**Application No.: 10/717,598**

**REMARKS**

## **AMENDMENTS TO THE DRAWINGS:**

4/34

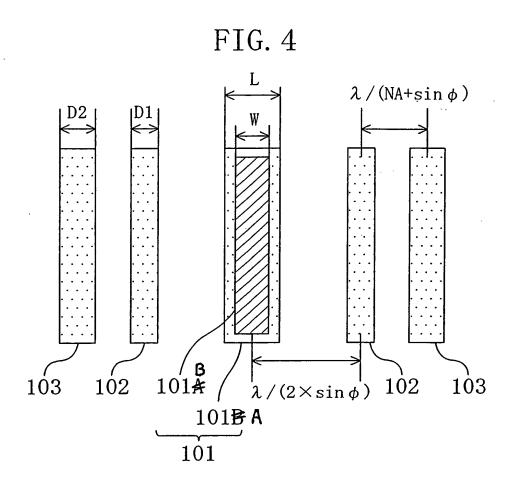
Please amend Fig. 4 as indicated on the enclosed copy thereof. Fig. 4 has been amended to show the correct designation of the semi-shielding portion 101A and the phase shifter 101B of the main pattern 101.

## FIG. 11B

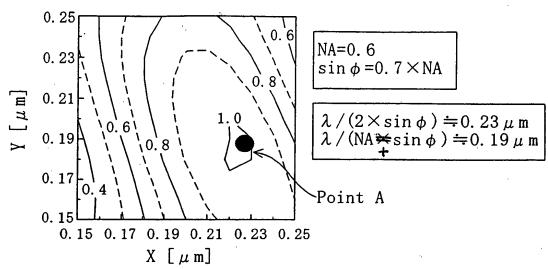
Please amend Fig. 11B as indicated on the enclosed copy thereof. Fig. 11B has been amended to show the correct equation for the distance Y.

FIG. 11C

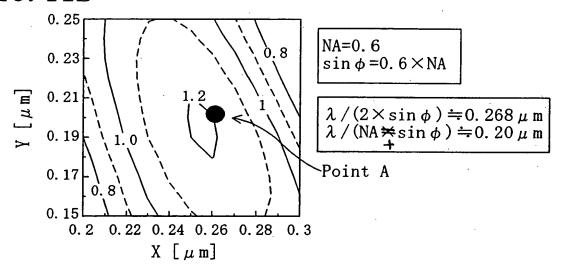
Please amend Fig. 11C as indicated on the enclosed copy thereof. Fig. 11C has been amended to show the correct equation for the distance Y.
